**ADDENDUM**  
(February 2014)

**2012 NDS Changes**

1) Add to section on “Dowel-type Fasteners” as follows:

Figure A1. Bolted connection cases A, B, and C.

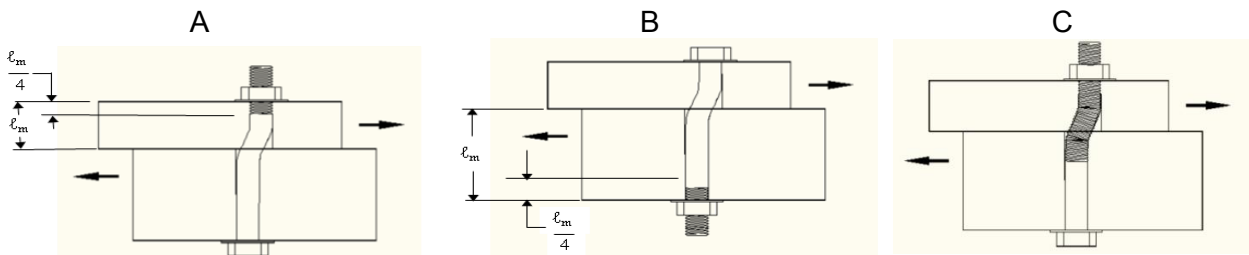
“Section 11.3.6 Dowel Diameter was renumbered to Section 11.3.7 and revised to remove a requirement that permitted use of fastener diameter,  $D$ , in lieu of fastener root diameter,  $D_r$ , in calculation of lateral connection values for bolts that conform to requirements of ANSI/ASME Standard B18.2.1. The change provides greater consistency with NDS provisions for threaded fasteners by establishing  $D_r$  as the default diameter for use in calculation of lateral connection reference design values. Provisions of 11.3.7.2 allow for use of  $D$  where the threaded portion of the fastener is adequately far away from the shear plane (e.g. threads do not exceed  $\frac{1}{4}$  of the full bearing length of the member holding the threads) or where a more detailed analysis shows that that moment resistance of the threaded portion due to its location in the connection does not control the yield limit state value. Reference lateral design values for bolted connections in Tables 11A through 11I continue to be based on diameter  $D$ . In accordance with Section 11.3.7.2, these tabulated design values are applicable for cases where the threaded portion is away from the shear plane as shown in Figure A1 cases A and B. For a bolted connection in accordance with Figure A1 case C, where threads are in the shear plane, tabulated lateral connection values based on  $D_r$  are applicable unless a more detailed analysis of the effect of the threaded portion on the controlling connection yield limit state value is conducted.”

Section	Description
Chapter 11	9) Provisions allowing lateral connection values of bolt connections to be based on fastener diameter $D$ , where bolts meet requirements of ANSI/ASME Standard B18.2.1, were removed. Applicability of $D$ for calculation of lateral design values is consistent with treatment of other dowel-type fasteners (Section 11.3.7.2).
